Inspection report	Sample Testing	RESULT
	Inspection number	INR-2305008	FAILED
	Inspection Date

Order Details				
PO NUMBER	MODEL	Brand	QTY	
DG23-BL0031	CELED65UHDSA23B7	Continental	1

1.1 / Internal Check - Main Board

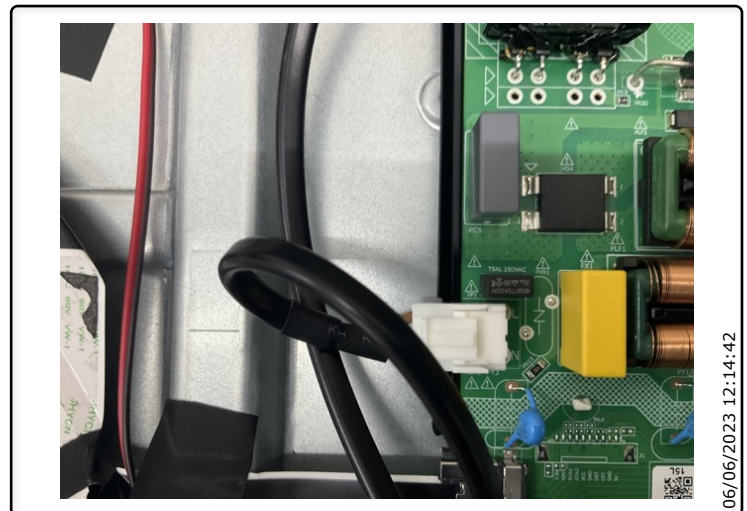
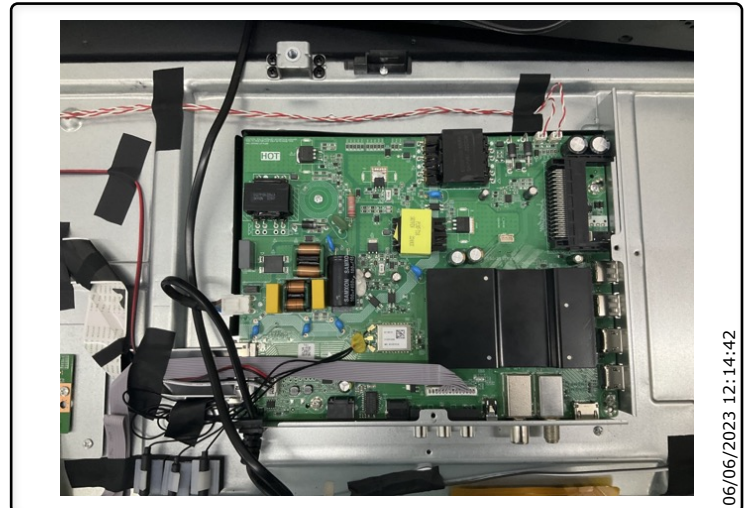
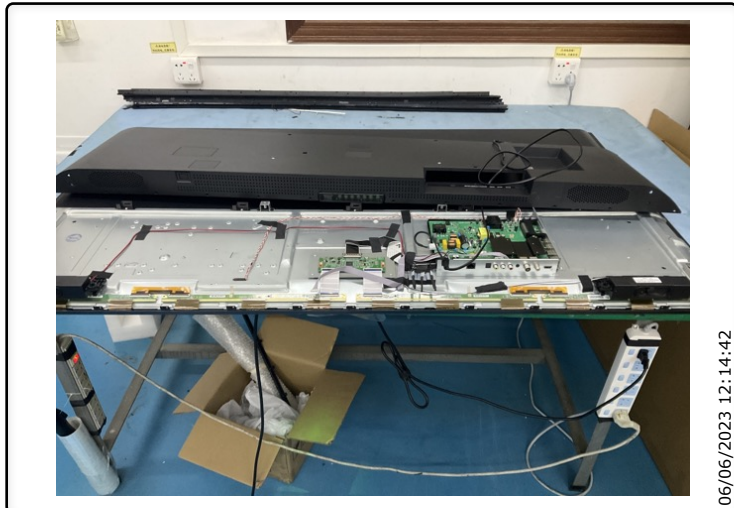
★ PO needs is P150-2851AV9.2 model main board , But sample is P150-2851AV9.7 model main board

1.12 / Internal Check - Power board

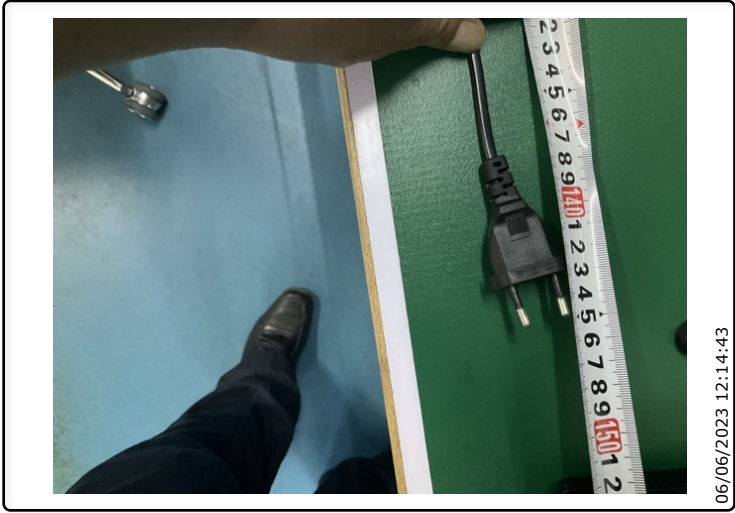
★ PO needs is P150-2851AV9.2 power main board , But sample is P150-2851AV9.7 model power board

4.1 / Functions - ATV Programs

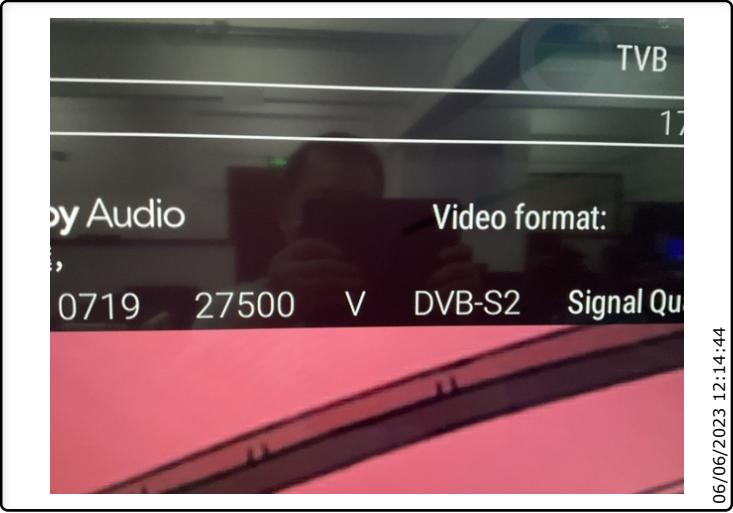
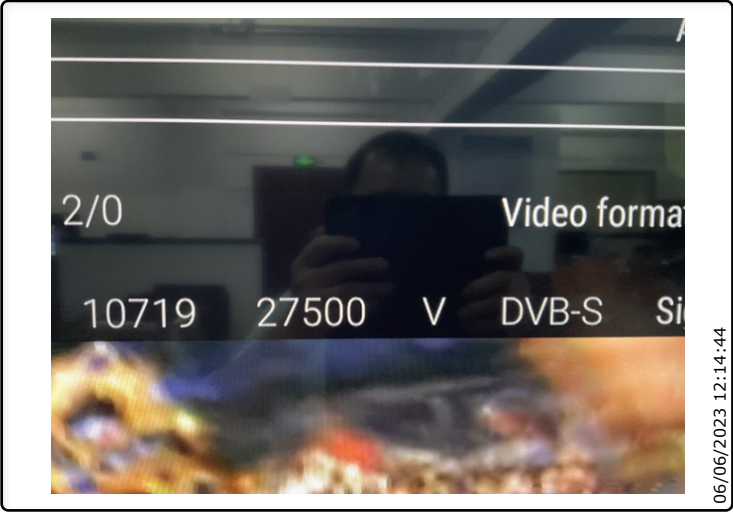
PAL-BG/DK --OK。Not support SECAM-L(不支持SECAM-L)--Accepted by France

5.3 / Software - First install guide

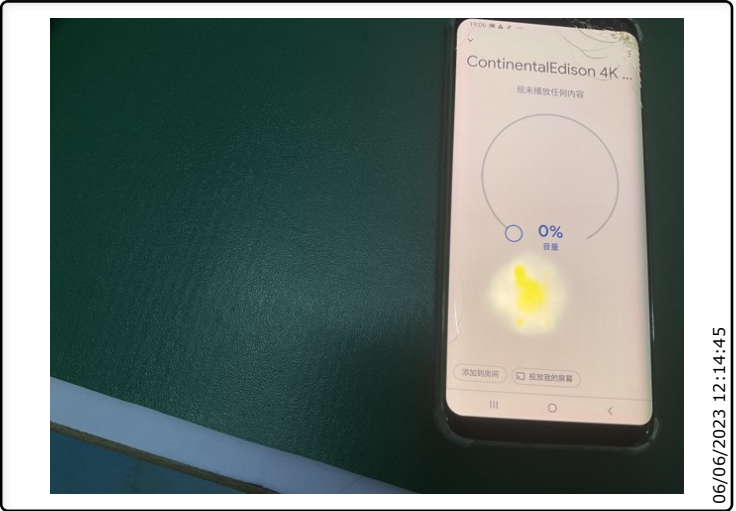
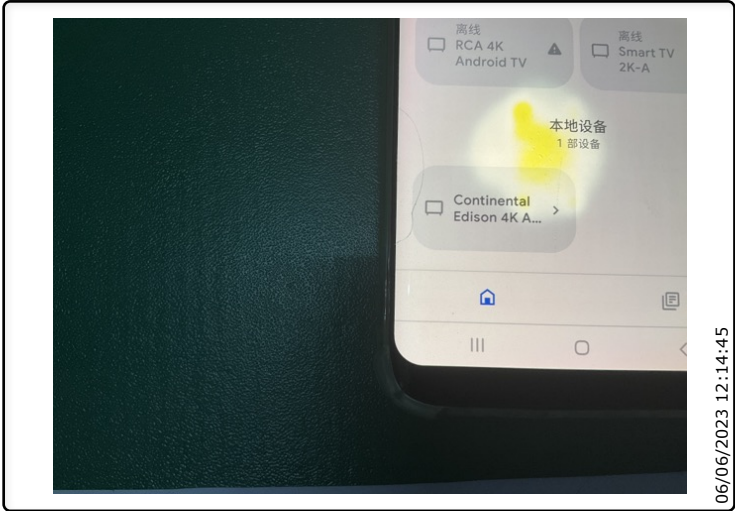
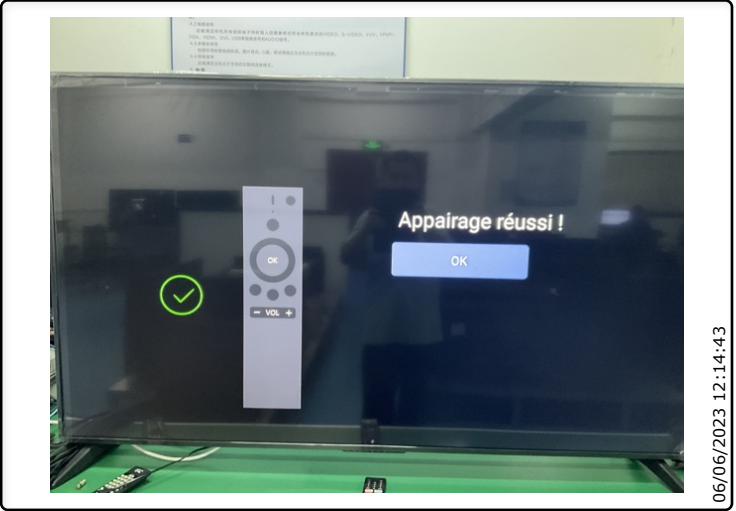
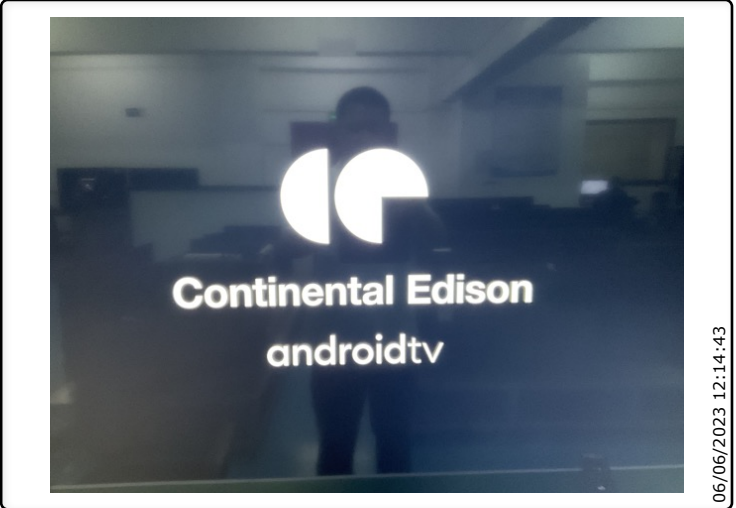
1.Need arrange the "language" selection after the open LOGO (需要将“语言”选择编排在开机LOGO之后)--Accepted 2:Needs to cancel sound of First install Guide.(需要取消首次安装指南的声音)。--Accepted 3.Needs to cancel "KONKA " character on menu(需要取消菜单上的“KONKA”字符)KONKA Reply:It's key for sample. plesae check in MP. It will be no 'Konka' character. ---Accepted

5.8 / Software - Timeshift

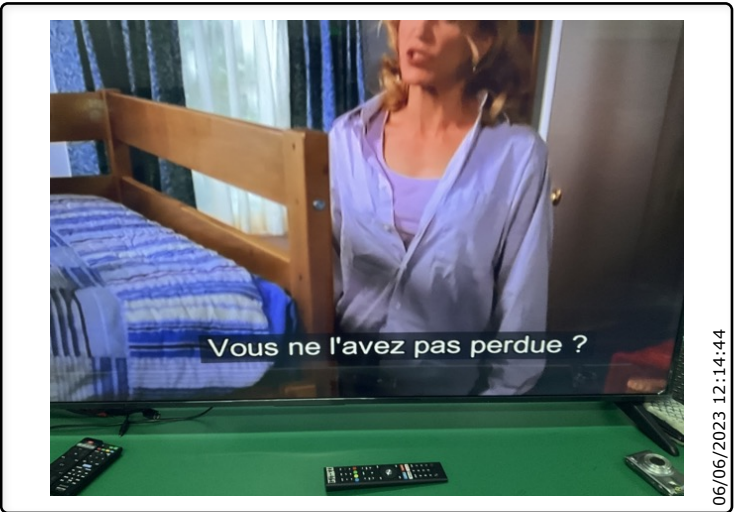
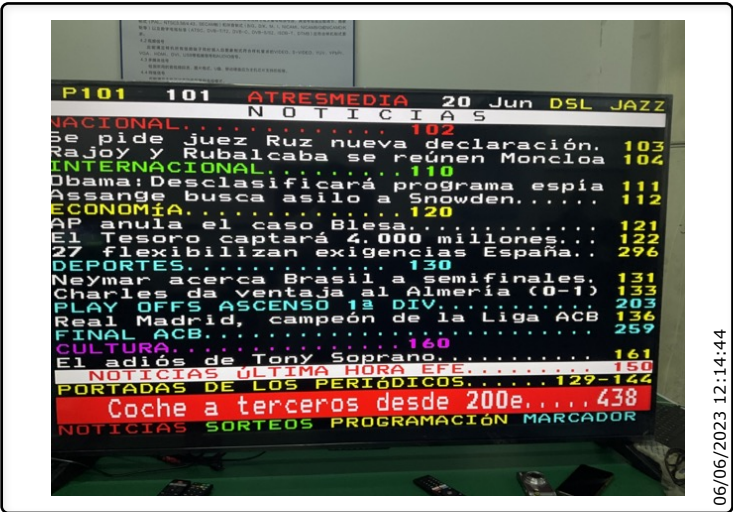
No Timeshift key on Remote control (But user menu has Timeshift function, But users operation will be troublesome)。遥控器上没有 Timeshift 键。(但是用户菜单有Timeshift功能, 但是用户操作将会很麻烦)。---- Accepted by France

6.3 / Panel - LED Display tester

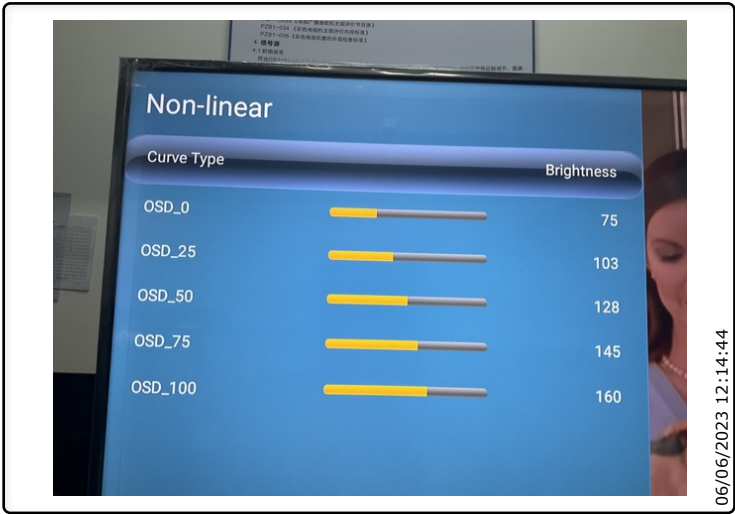
The brightness control functions only have a slight effect (亮度控制功能只有轻微效果)--Already fixed

7.7 / System - CI Information

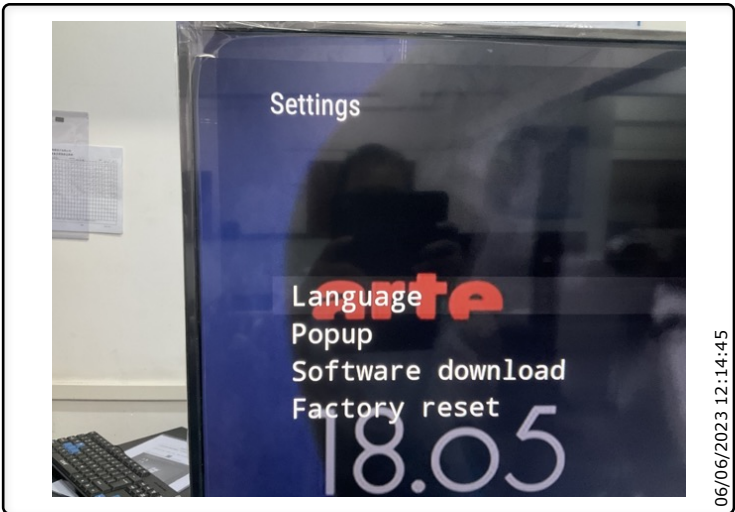
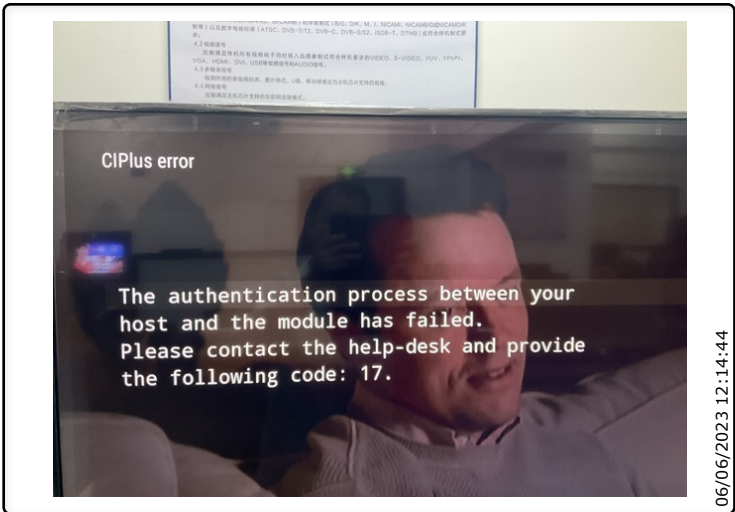
Cannot read CI card information in Digital Channel Setup, If according to such operation:live Tv> press ok->TV options -> Channel options -> Common Interface -> Common Interface Slot, Can read CI information。But users operation will be troublesome。(在Digital Channel Setup 不能读CI 卡信息。 如果按照这样的操作:liveTv>按 ok->TV options -> Channel optoins -> Common Interface -> Common Interface Slot。可以读取CI 信息, 但是用户操作将会很麻烦)。---- Accepted by France
